Performance Bulletin

June 2005

New Integral Motor Bracket Available

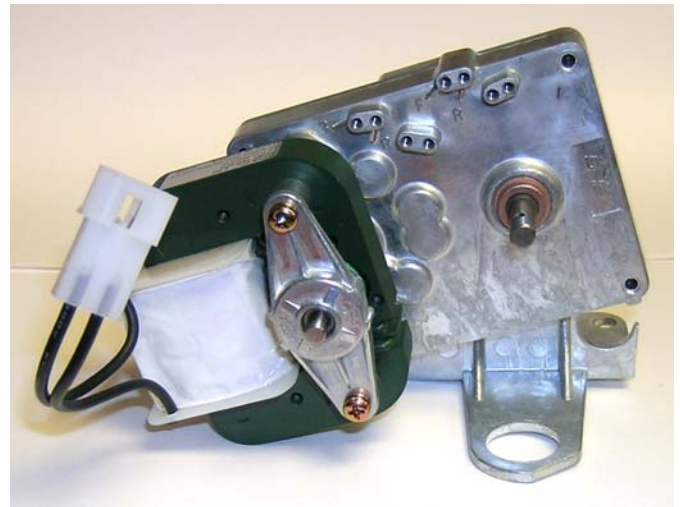
Starting September 2005, a new integral motor bracket is available for the 1500, 2510, 2750, 2850, and the upper drive motor on the 2900s. The motor is retro-fittable with existing backplates and will replace the existing motors and brackets for these models.

- Easy to remove and install
- Integral brackets provide improved support
- Less components to keep in inventory
- Integral brackets insure proper switch location
- Greater corrosion resistance, giving longer life in humid environments
- Ground location reduced from two to one
